BlueSky Professional Building

PLANNING RATIONALE

11405608 Canada Inc | [N45 ARCHITECTURE Inc.](#) | August 2020

The following is a response to Staff's Preliminary Comments from the meeting of 13 February 2020

View Lusk/O'Keefe

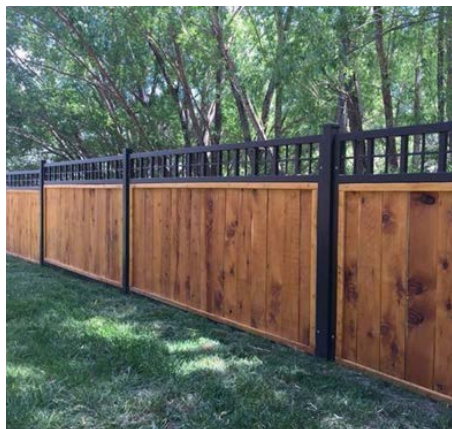
7. *Staff will look for rationale on the location of the building and how the parking is situated. Section 4.11 of the official plan encourages design elements that feature the corner or street access, please give consideration to design of the lot and how it plays to the Lusk/O'Keefe intersection.*
The site is small and a challenging shape. For our client to make best use of the site in a building shape that is economical and efficient, the site has evolved as presented. The siting of the building was also influenced by the municipal services "stubbed" to the site in the street at Lusk/Forager intersection. Refer to Site Servicing Drawings attached. To compensate, we have incorporated quality materials [unit pavers, stone, wood fencing] and generous use of indigenous and sustainable plant material in the design with a particular emphasis at the corner of O'Keefe and Lusk and at the main access to the site at Forager.

The approach to the edges of the site along O'Keefe and Lusk is designed to work with and compliment the City's planting, and with a focus on the intersection of the two streets. Here we have also created a low stone wall and rock garden/low berm to embellish the corner. From the parking curb to the curb at the street there is 12 m of enhanced green space from the parking lot to the municipal curb.
